**Design Addendum**

For Reselton Properties

This Design Addendum has been prepared in direct response to a series of comments provided by London Borough of Richmond Upon Thames regarding the submitted proposals for the former Stag Brewery site in Mortlake.

Revised proposed north elevation of Building 2

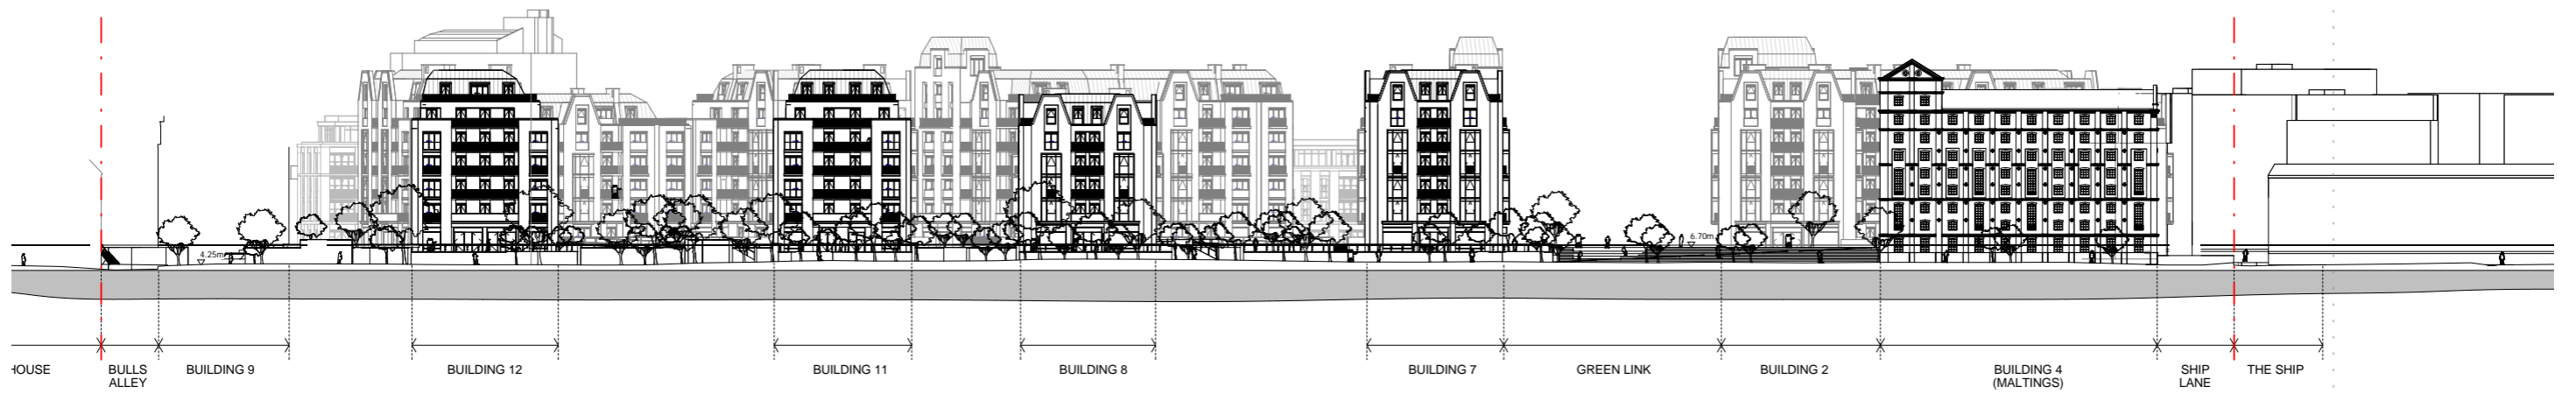
- 3. River elevation - forward project in elevation looks much greater than it actually is. To improve proportions - widen gables; increase width of commercial units at ground floor.

While we disagree that the gables should be re-designed, we acknowledge that there could be opportunity to increase the amount of glazing and visibility in to the ground floor commercial units and will alter these elements wherever we think there is opportunity to successfully do so.

The riverfront elevation and CGI opposite clearly demonstrate that there is significant variation in the design of river facing elevations. Buildings 11 and 12 are terminated with single bays while buildings 7, 8 and 2 vary in height and terminate with gables. The result is an undulating roofscape with varied appearance. Furthermore, the metalwork details and colours of brick and metalwork are proposed to vary within each of the three mansion 'clusters' (B11 and B12, B7 and B8 and B2 and B3) further adding to the variety of the overall appearance of the masterplan.

Proposed typical floor plan - Buildings 2 and 3

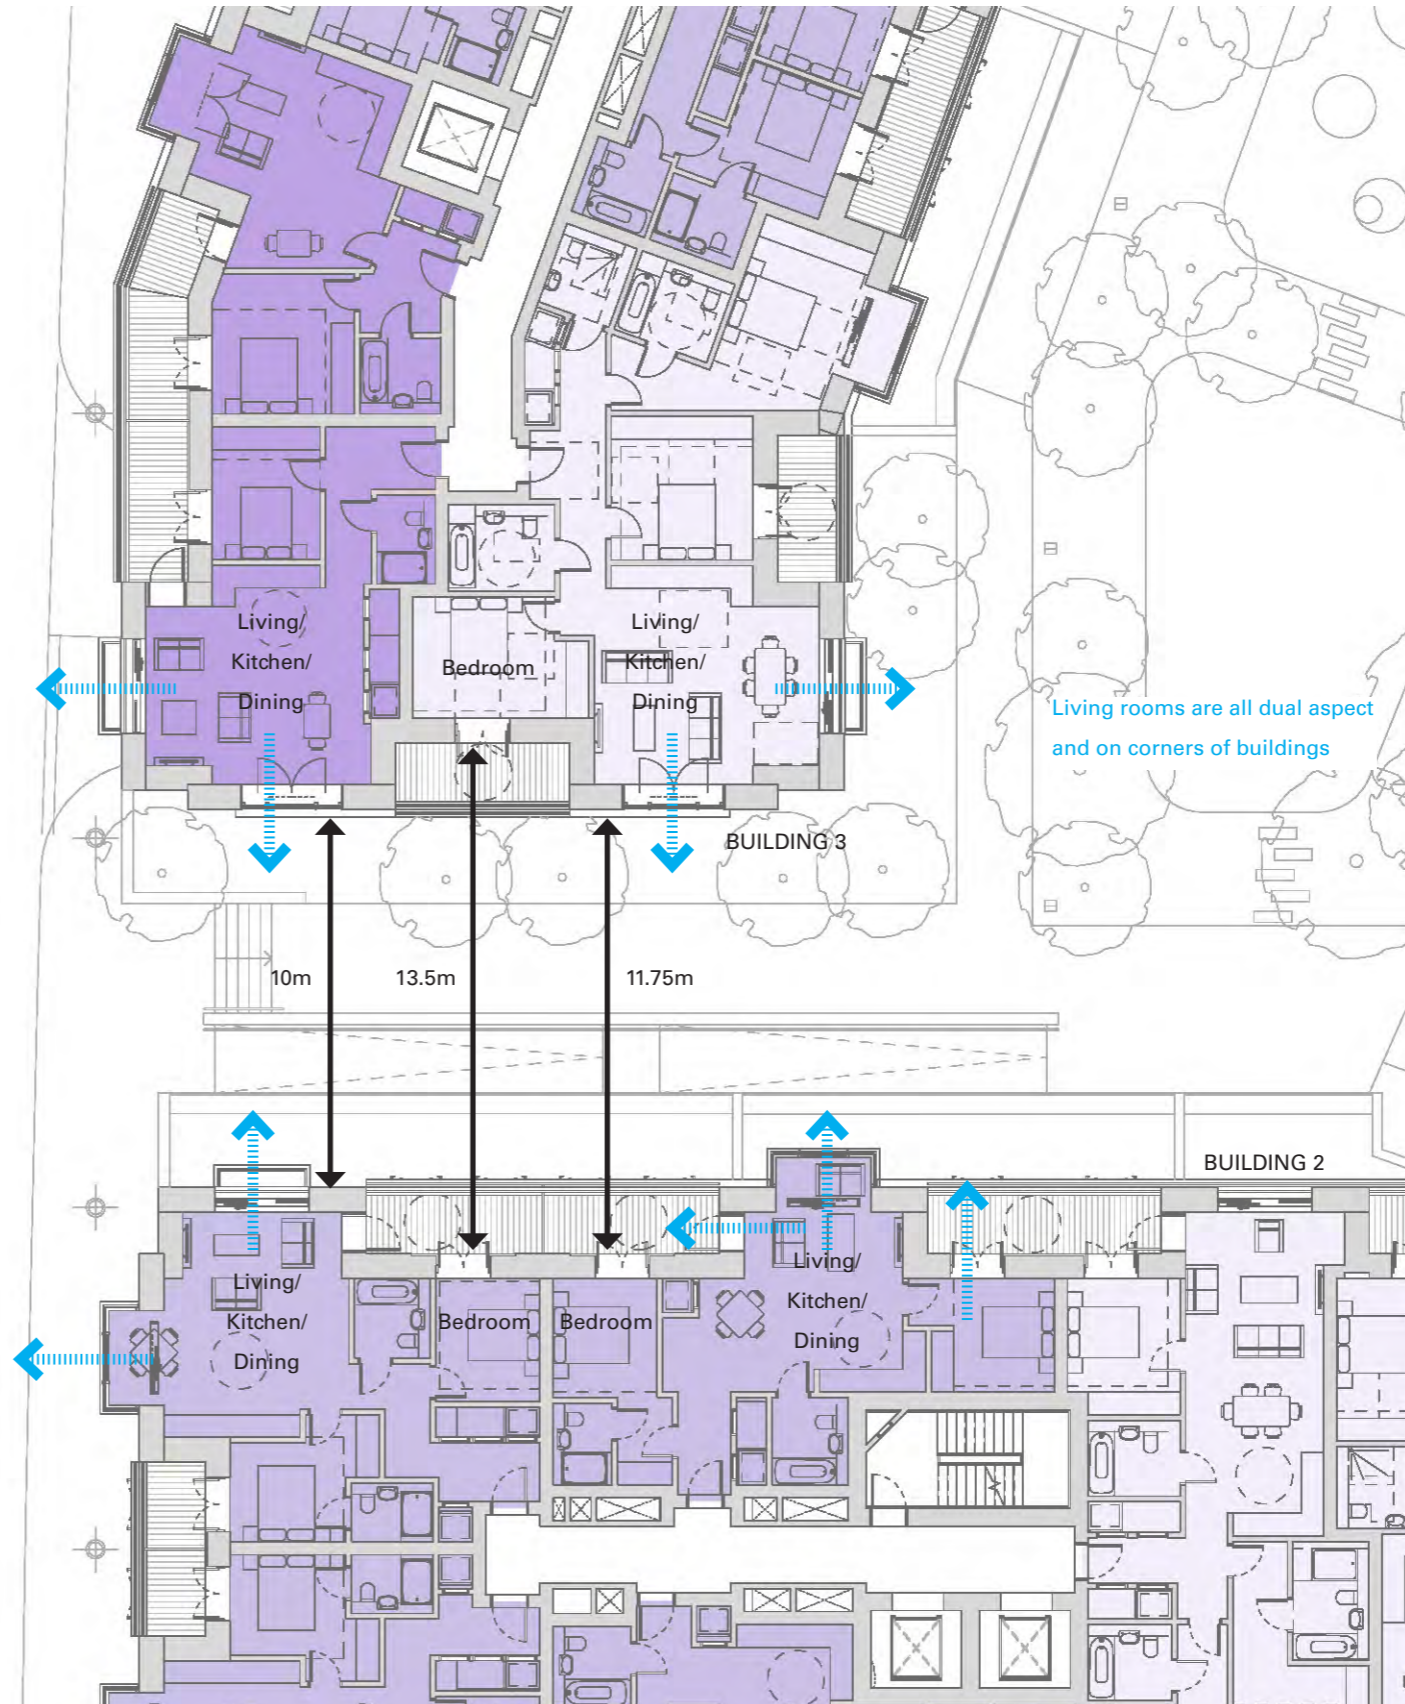
- 4. Block 2 with Block 3: North facing, single aspect, only a 10m distance (and 12m on upper floors) - unacceptable living conditions.
- 5. Block 2 with Block 1: only 13m separation.

Please see section dedicated to 'Proximity of Buildings'.

Block 3 - proposed ground floor plan

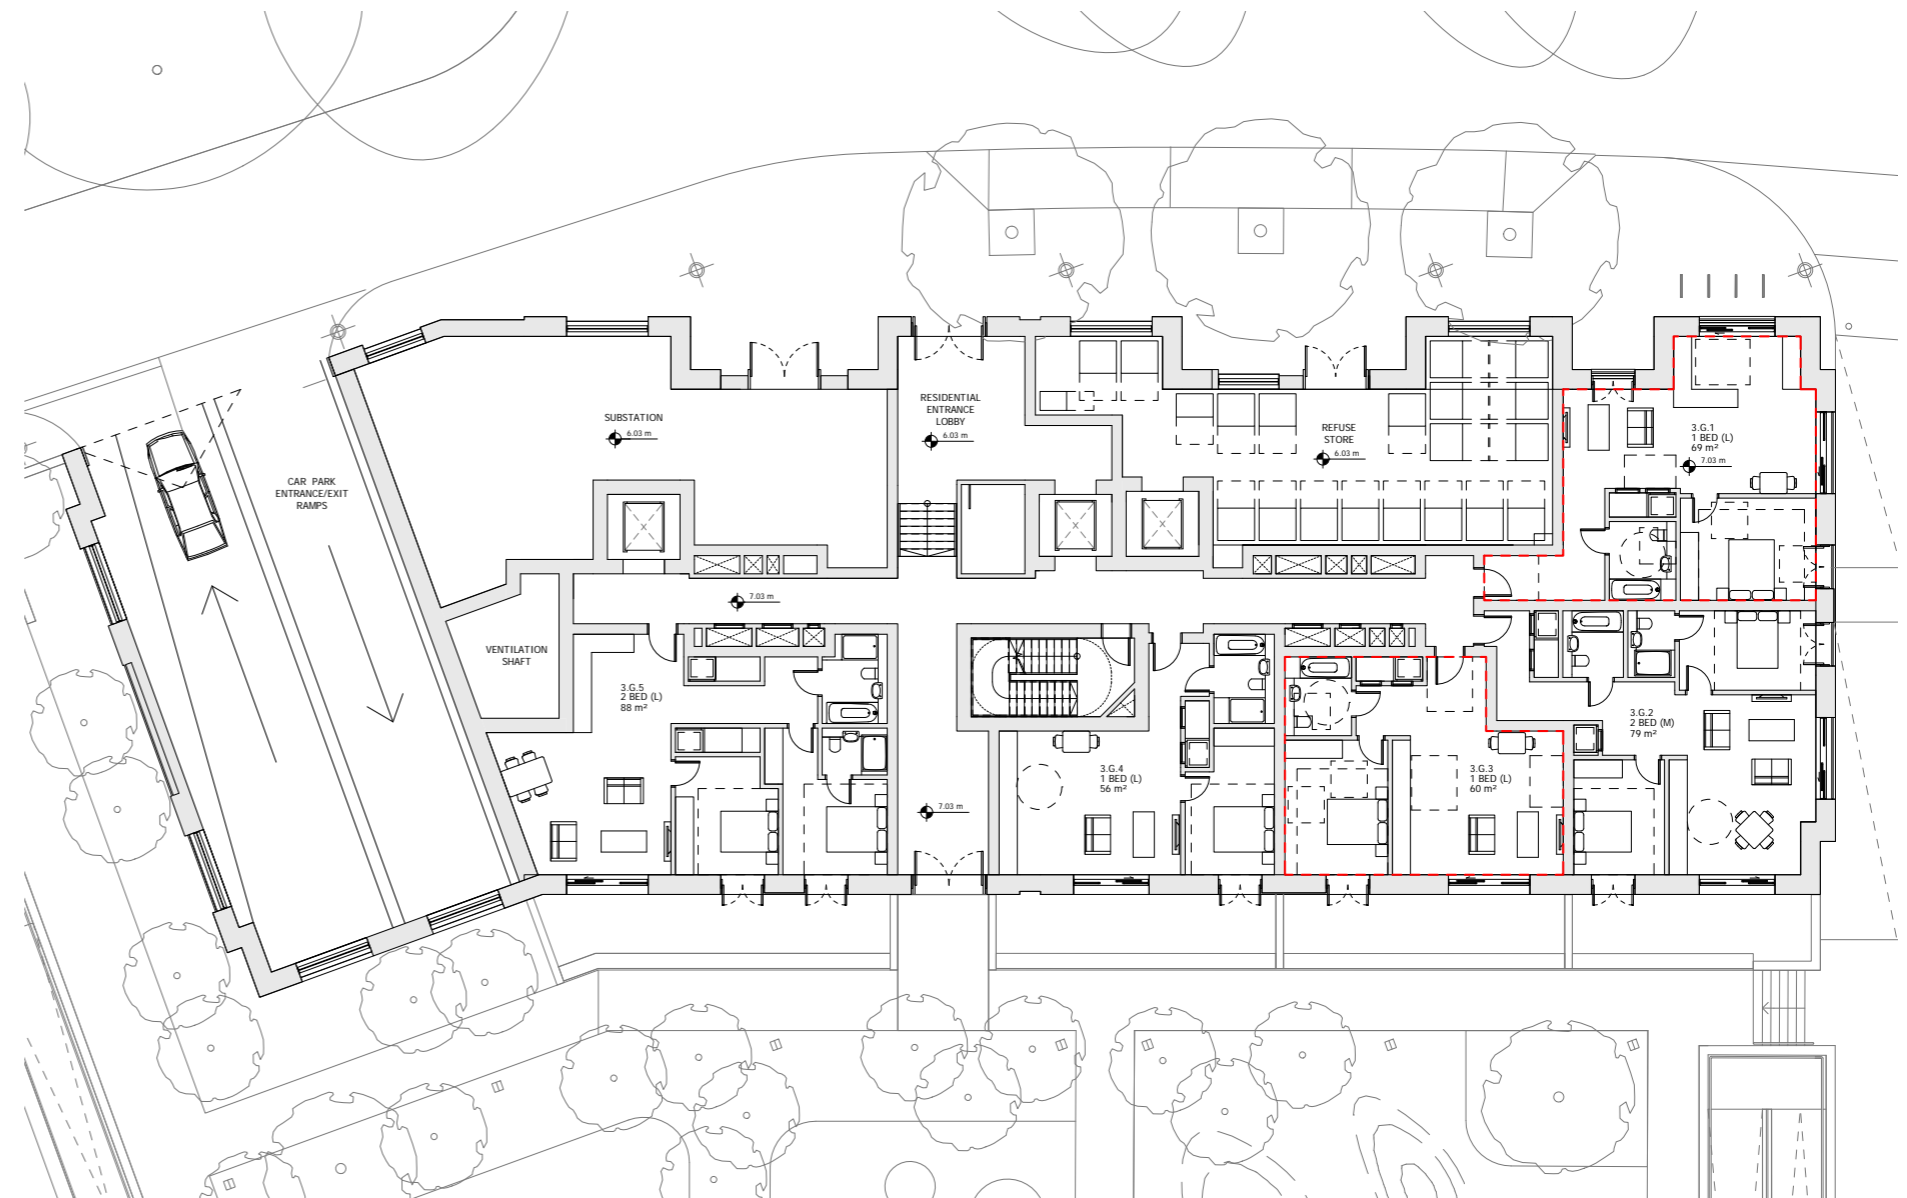
1. West elevation - It is appropriate to have a one bedroom flat next to refuse.

2. South elevation ground floor - insertion of grilles. The west elevation has 5. Poor solution to this frontage at street level. Creates inactive/ dead frontage.

On both items 1 and 2, a more in depth understanding of the refuse collection and servicing constraints as a consequence of statutory requirements is required.

In the first instance refuse must be collected from an accessible vehicle route within a maximum distance from the rear of the refuse vehicle. Refuse from the cluster of buildings 2 and 3 are proposed to be collected from a combined refuse collection store at the ground floor level of B3. This arrangement has been made to enable ease of access to the refuse vehicle, which will collect from Ship Lane. The ground floor of B2 was dismissed as a suitable location since the refuse store would likely occupy the majority of the frontage of the primary thoroughfare of the new 'high street'.

Three of the five sets of grilles are to the refuse collection store. The other grilles on the west facade of the ground floor of B3 are to the substation that serves the western portion of development area 1. This location has been chosen to provide ease of access to maintenance vehicles and personnel in accordance with statutory requirements.

In order to improve the visual appearance of these grilles we would suggest that the design of the metalwork is conditioned and samples and drawings are submitted for approval at a later date.

Block 4 (Maltings) - revised north elevation

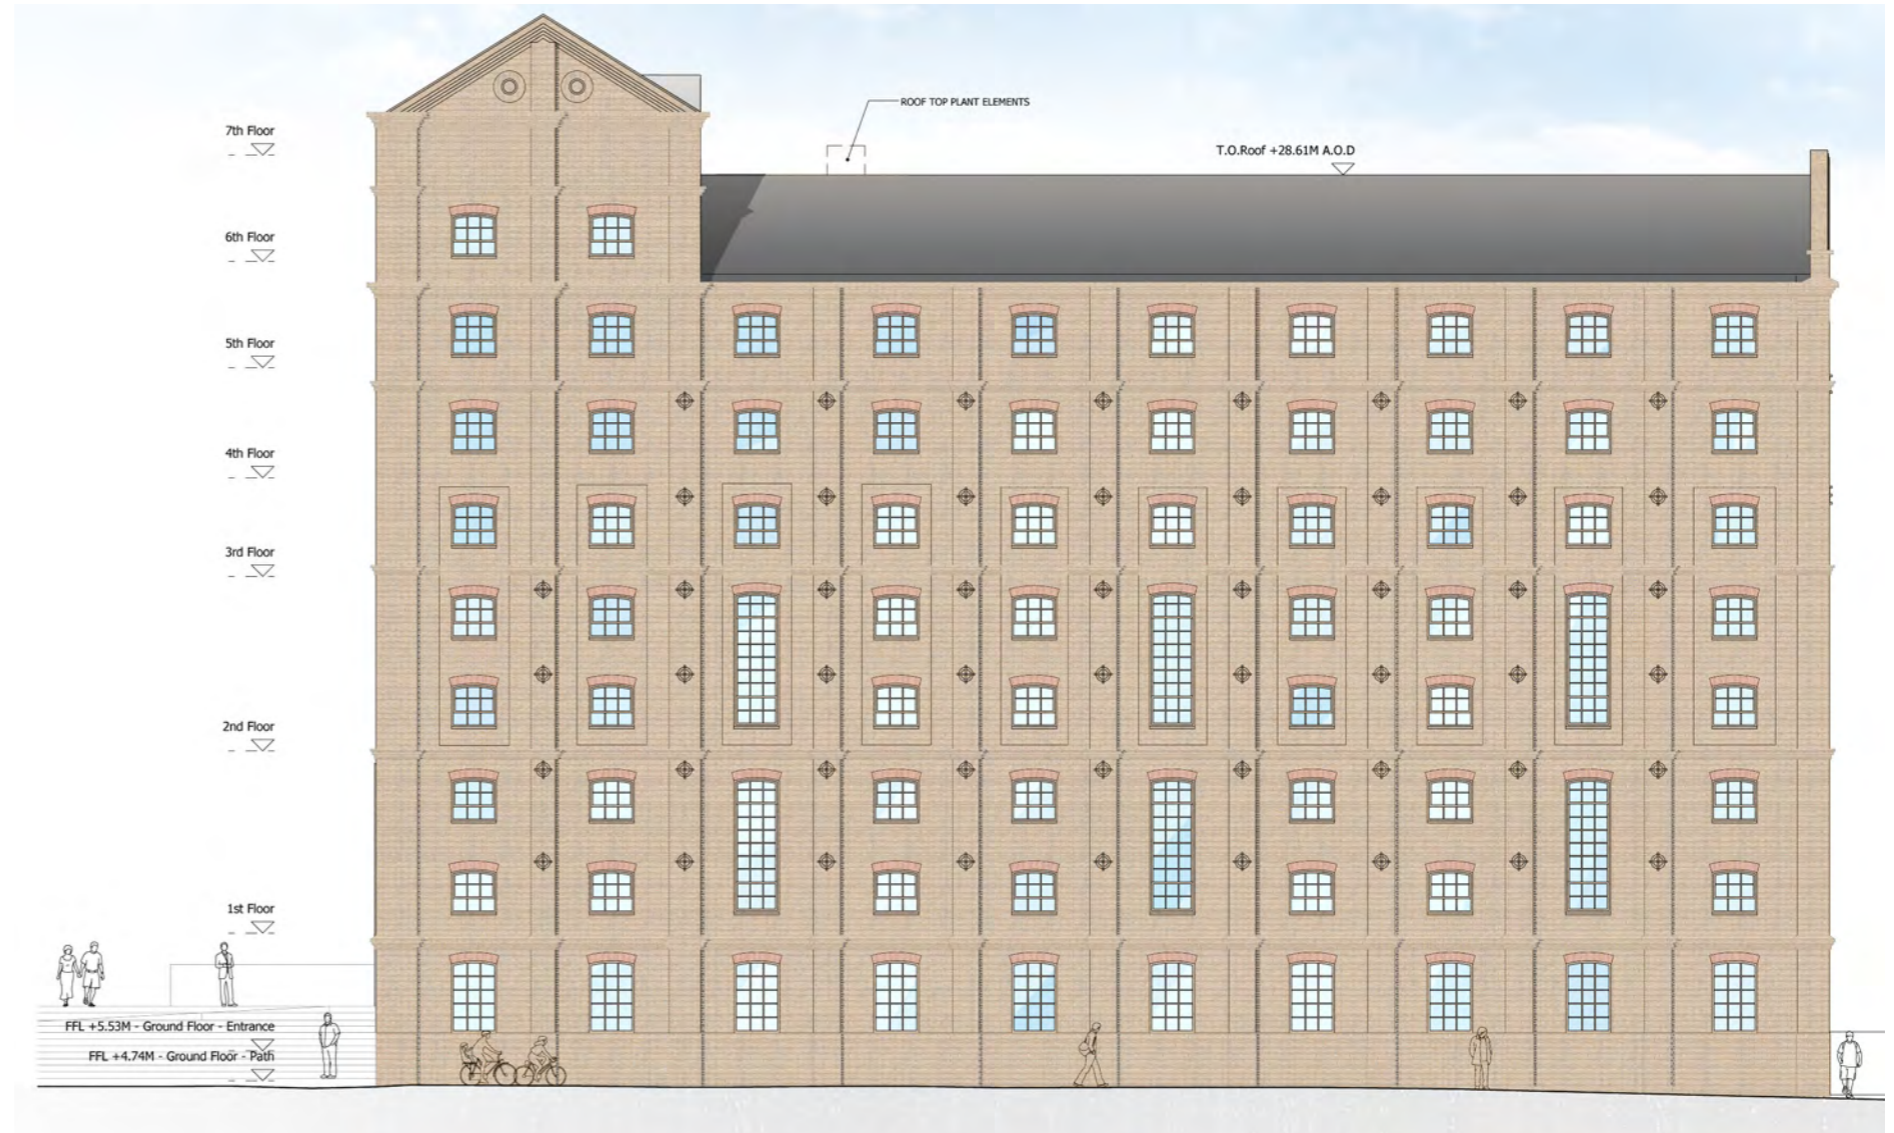
2. The double height windows to the 1st/ 2nd and 3rd/4th floors in the western element which is crowned with the gable gives a slightly lopsided effect to the fenestration pattern. There should be symmetry of the existing elevation. (Omit).

3. Remove Juliette balconies to the double height windows.

Placement of double height windows has been re-considered to provide a less disruptive impact on the existing elevation.

The double height windows have been re-designed and balustrades to 'juliette balconies' have been omitted. It is also proposed that existing columns will be re-located within the ground floor entrance area to the community use space. The ground floor plan has been revised to show indicative locations.

Block 4 (Maltings) - proposed section

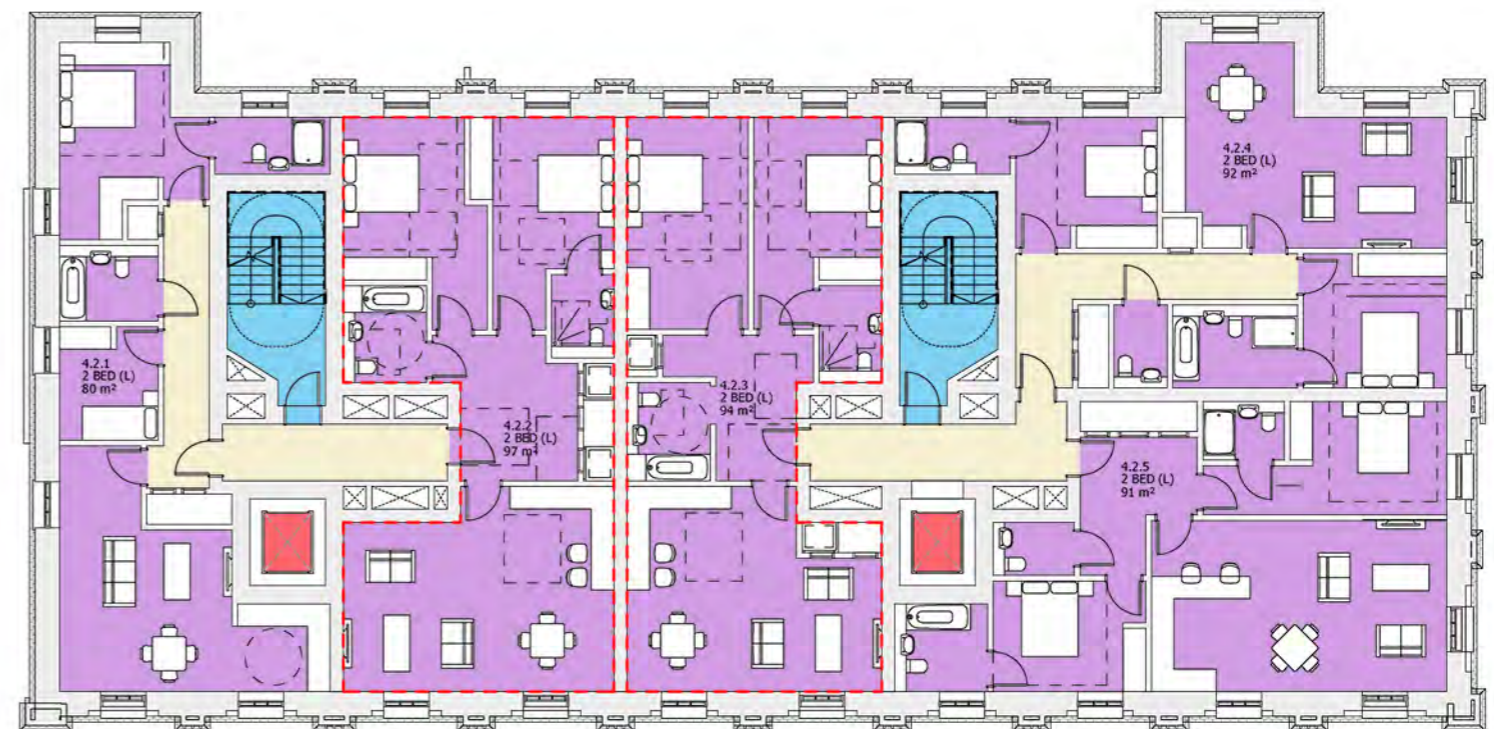
1. Provide further justification for double height windows. Provide section through building demonstrating why these are necessary - west to east; and north and south through each flat. (It is evident some flats do not have these, so failing to see justification for such).

Section drawings have been provided to relationship of double height windows to internal apartments and or/ duplex units.
